**Final Statement of Reasons for Rulemaking**  
Including Summary of Comments and Agency Response

PUBLIC HEARING TO CONSIDER THE ADOPTION OF A  
REGULATION TO REDUCE METHANE EMISSIONS FROM  
MUNICIPAL SOLID WASTE LANDFILLS

**Public Hearing Date: June 25, 2009**  
**Agenda Item No.: 09-6-3**

**Figure 1. Comparison of SCAQMD Landfills with non-SCAQMD Landfills**

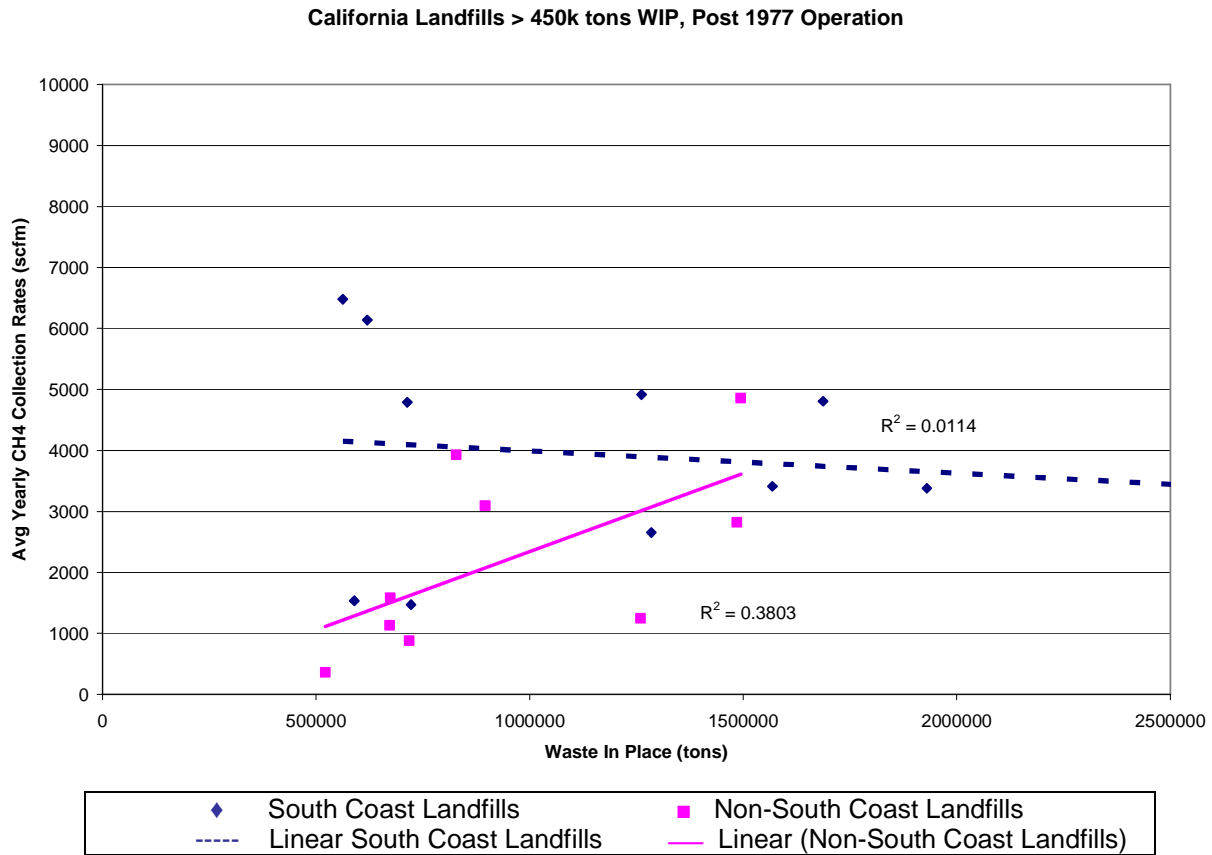
- 33. Comment:** We recommend that ARB staff focus on analyzing the differential gas collection rates between landfills that are under SCAQMD jurisdiction and those located elsewhere in the state. (CAW)

**Response:** As suggested by CAW, ARB staff evaluated an alternative method for estimating the emission reduction benefits of the approved regulation by comparing existing site-specific methane collection rates for South Coast landfills, which are subject to requirements similar to the approved rule, with non-South Coast landfills. Staff used the methane volumetric flow rate before the destruction/control device as the measurement of the methane generation rate. Certain minimum site-specific data was needed for this approach including: landfill size, age, methane collection rates, amount of waste-in-place, and the presence of gas control systems. In most cases staff did not have site-specific data for moisture content or waste composition, so a 50 percent moisture content was assumed for all landfills.

Figure 1 shows that there is little correlation between waste-in-place and collection rate as shown by the low regression values of 0.0114 and 0.3803 for South Coast and non-South Coast landfills, respectively. The lack of correlation between waste-in-place and the collection rates raises concerns about using the small sample of gas collection rates to estimate the emission reductions from the adopted rule and the impact on collection efficiency.

The data suggests that, for landfills in the 500,000 to 1 million tons of waste in place range, enhanced monitoring, similar to the adopted rule, would more than double methane capture. However, in the 1 to 2 million tons of waste in place range, enhanced monitoring, similar to the adopted rule, would provide few additional benefits. This clearly suggest that an approach using only the difference between gas collection rates for landfills in the South Coast and those outside the South Coast cannot be used to reliably estimate the overall collection efficiency of the rule.

These shortcomings show that this alternative method, which is based on the single metric “methane collection rate,” cannot be used to estimate statewide emission reductions. In order to use this alternative method, a full range of site-specific data is needed. Unfortunately, the necessary site-specific data are not currently available and is unlikely to become available within the next few years. Accordingly, in absence of the necessary site-specific data, the modeling approach outlined in Chapter IV of the Staff Report to estimate statewide emission reductions is both reasonable and appropriate.
